TENNESSEE VALLEY AUTHORITY

Watts Bar Nuclear Plant (WBN) Safety Evaluation Report (SER) NUREG-0847 issued June 1982) Section 3.11 "Environmental Qualification of Mechanical and Electrical Equipment" states that an audit of the WBN qualification files will be required as part of the NRC staff's review of the WBN equipment qualification program. This subject audit was conducted on February 14-16, 1984 and consisted of a review of the qualification files for eleven electrical components and subsequent field walkdown to ensure that a parallel existed between the installed component and the component qualified.

50-390
Responses to NRC 840214016 audit findings re
util equipment qualification program, per
NUREG-0874

GENERIC COMMENTS ON ENVIRONMENTAL QUALIFICATION PROGRAM

FIGURE X-1: PHASE I HELB PROFILE

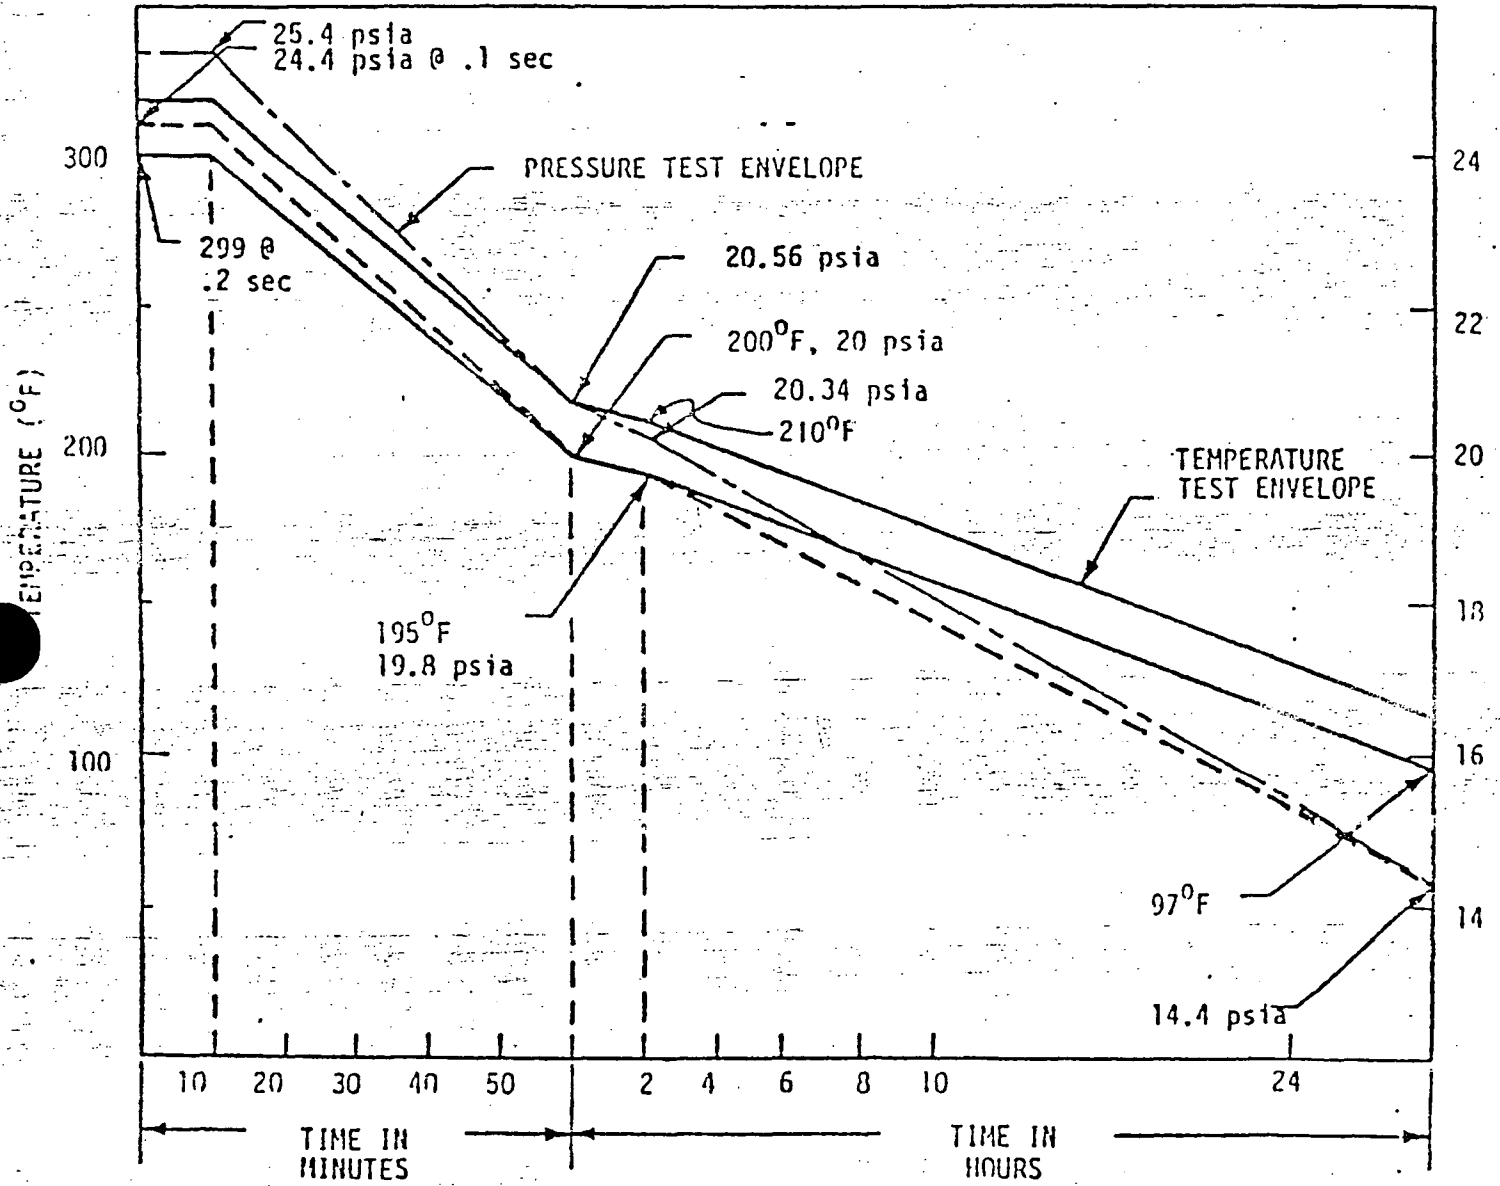
1. The terminal blocks qualification is based only on the material analysis. However, it should be noted that NUREG-0588 category II requirements which are applicable to Watts Bar, allows the material analysis only for aging consideration. In order to demonstrate the qualification of the terminal blocks either a new test should be performed or some old test on the similar equipment should be referenced.

In addition, Wyle Laboratories has demonstrated a 10-year qualified life for the CR151 terminal blocks (Test Report 17503-1) for a high energy line break (HELB) accident with the following environmental parameters:

Temperature: 315°F (approximate)
Pressure: 25.4 psia

A copy of the HELB test profile is attached. Although the documented test data on the terminal blocks do not envelope the worst-case environmental profile of their installation, the data used in conjunction with the material analyses allows us to conclude that the blocks are qualified for the more severe environmental conditions.
